Rezoning Transportation Analysis

Petition Number: #2022-125

Date	Description
12-29-22	First Review (TM)

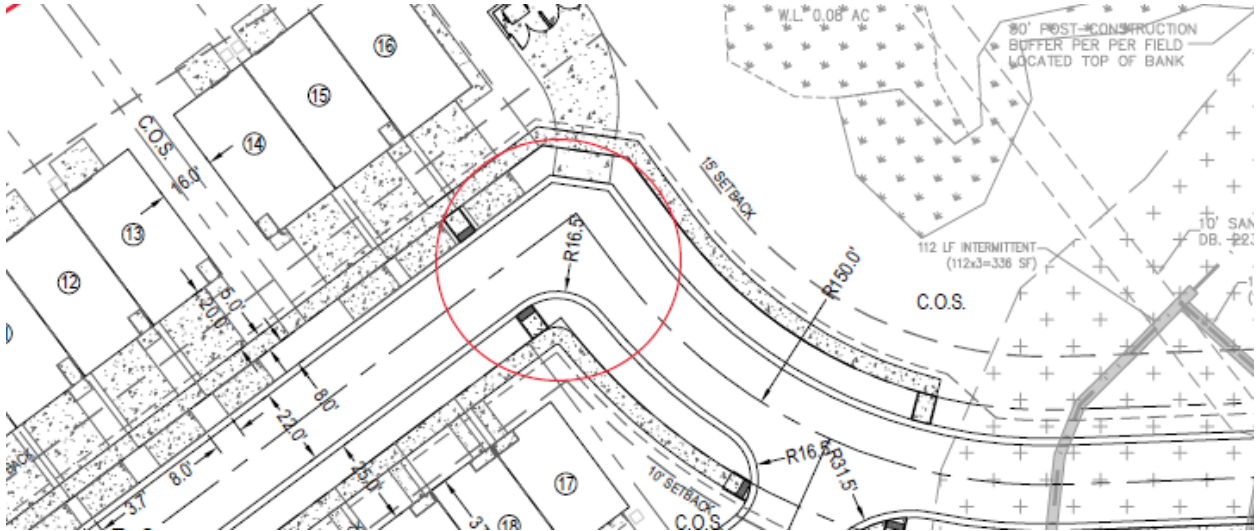
1. Curblines:

- a. **Tennyson Drive:** Location of curb and gutter is in its existing location..

Label and dimension the curb and gutter from the centerline for each road on the site plan.

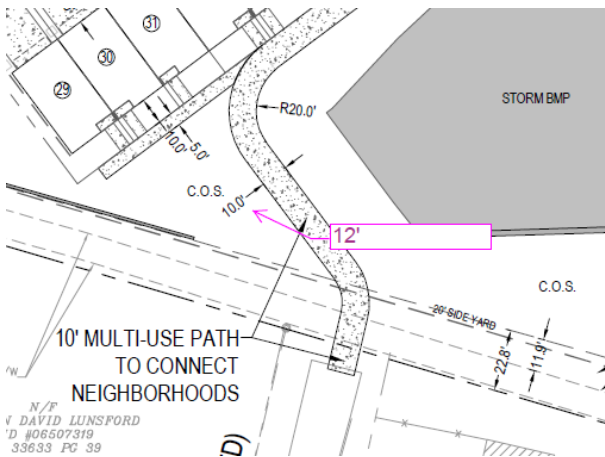
- 6. Revise site plan and conditional note(s) to meet CDOT standards for public roadway geometry. Label each roadway as public or private.

7. Revise site plan and conditional notes(s) by changing the 10-foot Multi-use path to a 12-foot multi-use path.
